DOMINION ENERGY KEWAUNEE, INC.
KEWAUNEE POWER STATION
RESPONSE TO REQUEST FOR ADDITIONAL INFORMATION:
LICENSE AMENDMENT REQUEST 244, PROPOSED REVISION TO
RADIOLOGICAL ACCIDENT ANALYSIS AND CONTROL ROOM ENVELOPE
HABITABILITY TECHNICAL SPECIFICATIONS (TAC NO. ME7110)

ME7110-RAII-AADB-Brown-001-2012-05-13

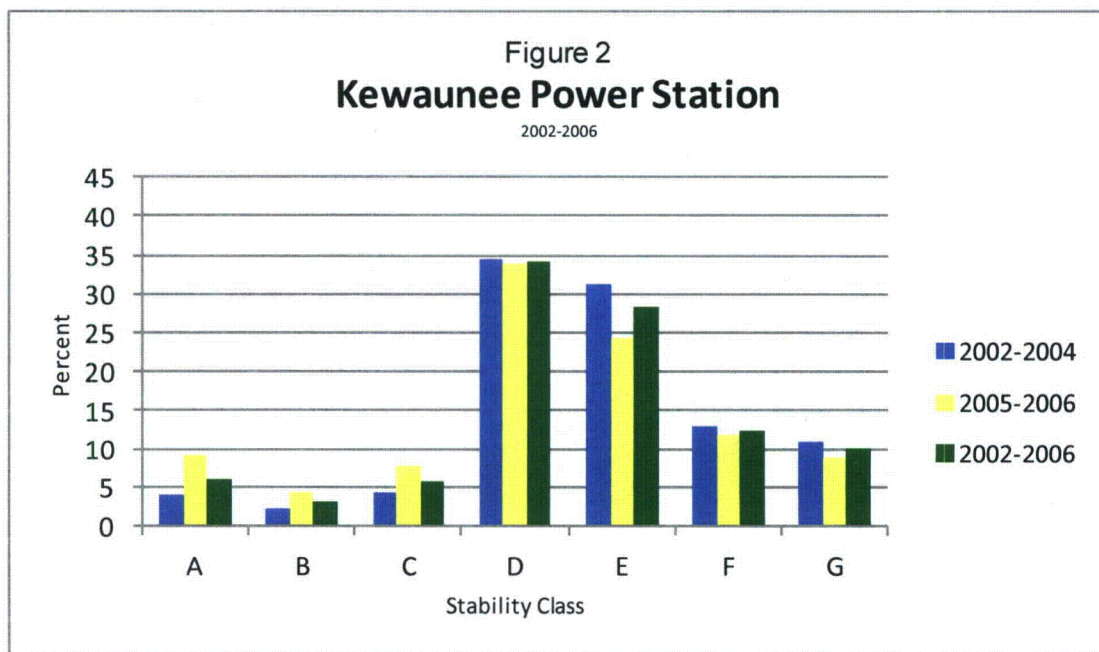
- f. Discuss the decrease in the frequency of occurrence of stability class E from approximately 35 percent in 2002–2004 to approximately 20 percent in 2005–2006.

To compare stability class occurrence between the two subsets of data within the 2002-2006 data, Figure 2 was created to display the percent of stability occurrence for 2002-2004, 2005-2006, and the combined percentage of occurrence over 2002-2006. The stability occurrences in the new data file show no significant difference between the frequencies in each sub-set of data or to the overall frequency of the entire data file.

- f. As shown in Figure 2, the differences noted in the frequency of occurrence of stability class 'E' is much less in the new data file between the two sub-sets of data. From annual data displayed in Figure 1, average stability occurrence fluctuations from year to year are not uncommon. In fact, stability fluctuations for 2002-2006 compared to 2008-2011 data are similar. DEK is confident that the new data file used to perform X/Q analyses in support of LAR-244 is appropriate and provide adequate representation of local atmospheric dispersion.

Figure 4

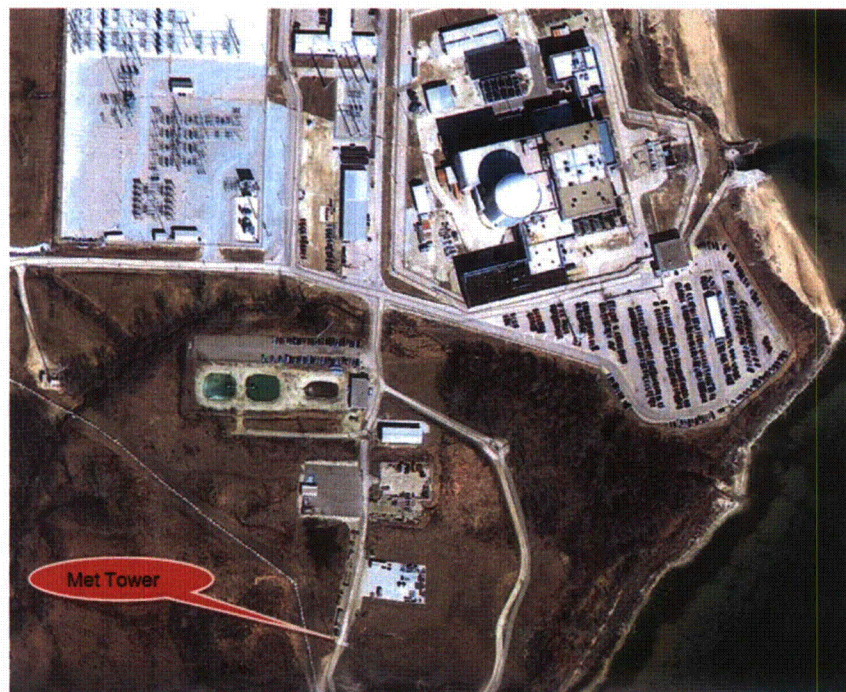
Request: "Discuss the occurrence of stability class 'A' for periods longer than 12 consecutive hours in 2005–2006 (maximum length of 41 consecutive hours) as compared with the maximum length of occurrence in 2002–2004 of 10 hours."

DEK subsequently learned that there had been land-use and land-cover (LULC) changes to the area surrounding the meteorological towers starting in 2005. Some things that have changed (since September 2004 / early 2005) were Parking Lot C was paved and a new gravel storage lot was created. Both lots are located to the North of the primary meteorological tower (see Figure 3 below).

Figure 4 shows the location of the meteorological tower on the Kewaunee site and Figure 5 provides a prospective of Kewaunee located approximately four miles from Point Beach Nuclear plant on Lake Michigan.
